# Variance Appeal VAR21-00002

Concerning: 735 Quail Tail Trail Variance

From: Quail Tail Trail Property Owners

Variance  
Application No.  
VAR21-00002

# Variance Requests

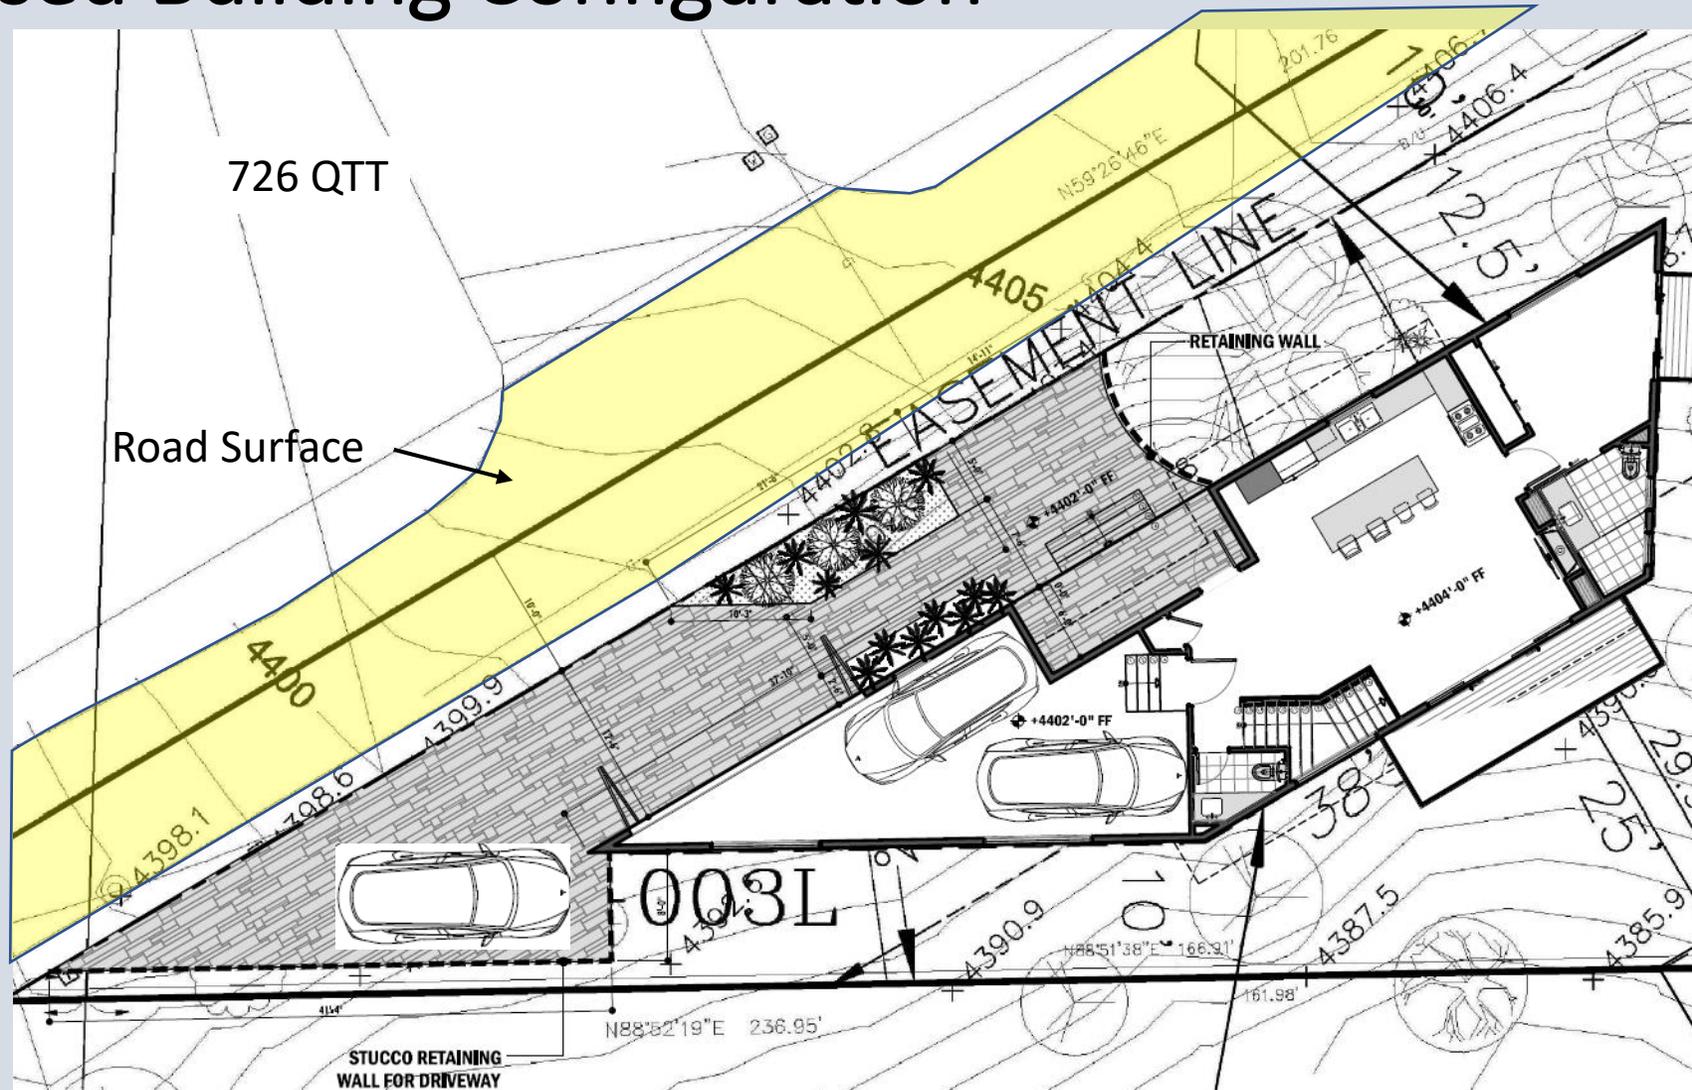
- Non-standard shape (triangular) garage
  - Effectively makes garage unusable for parking
  - Makes parking outside the garage necessary
  - Requires accordion doors that extend 5' into driveway space
- Driveway length less than 20'
  - Encourages cars to intrude into roadway
- Driveway width greater than 30'
  - Appears to be needed for parallel parking at house
- Retaining wall exceeds allowable height without step backs
  - Appears to be sought for additional parking areas
  - Creates a safety hazard from falls

# Driveway Requirements from LDC

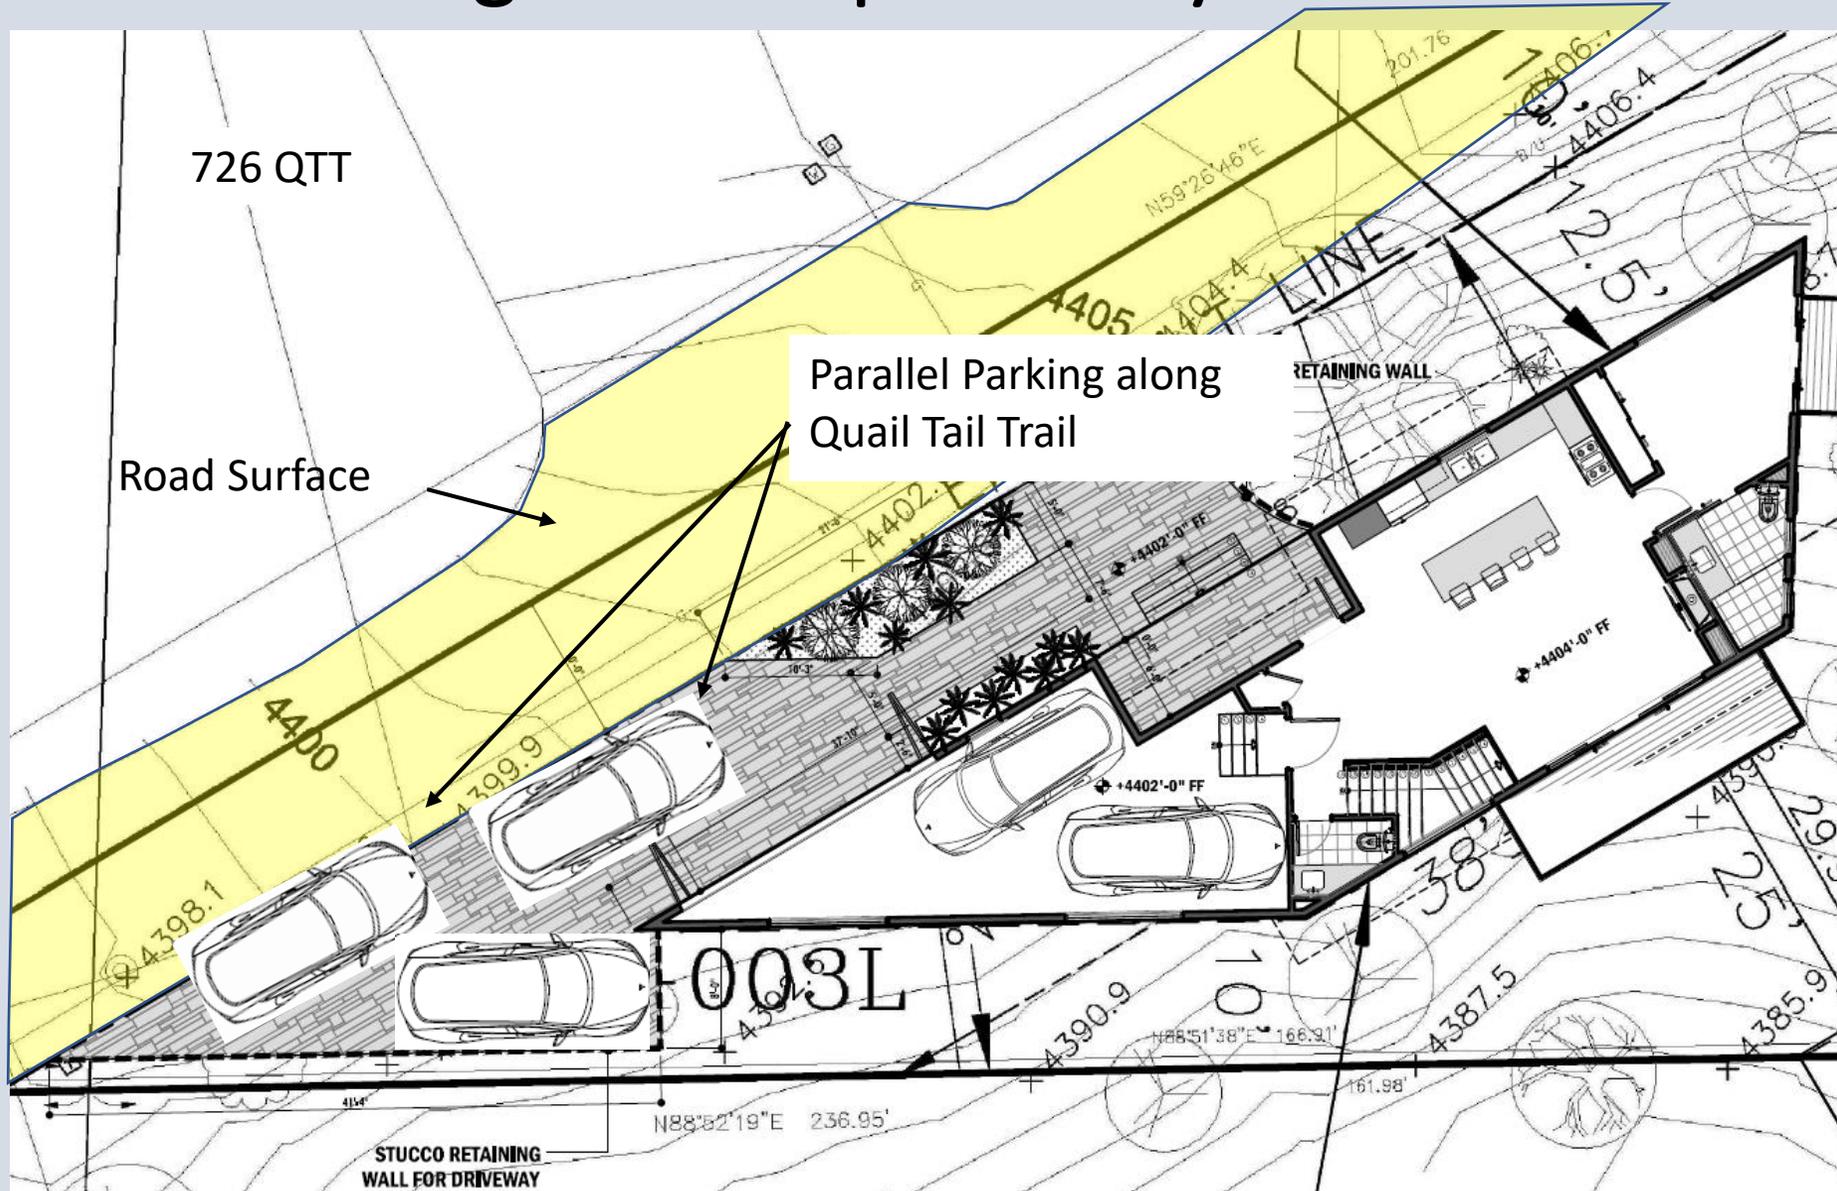
- Proposed driveway is only 12.5' long and over 50' wide
- Does not comply LDC and will lead to cars in front of garage extending into roadway
- Additional width will encourage parallel parking on roadway

- (3) c. Driveways shall be no less than 20 feet in length over the entire width of the garage, carport or other structure intended to house vehicles, from the face of a garage, carport, or other structure intended to house vehicles to the near edge of the sidewalk or public right-of-way. This distance may include the area between the property line and the edge of the street if the City Engineer determines that it will not conflict with existing or future rights-of-way, sidewalks, pedestrian pathways or similar improvements. All required parking must be located completely within the boundaries of the residential property.
- d. Within the front and exterior side setback area, each driveway at its widest point shall be not more than 30 feet in width, measured at right angles to the center line of the driveway, except as that distance may be increased by permissible curb return radii.
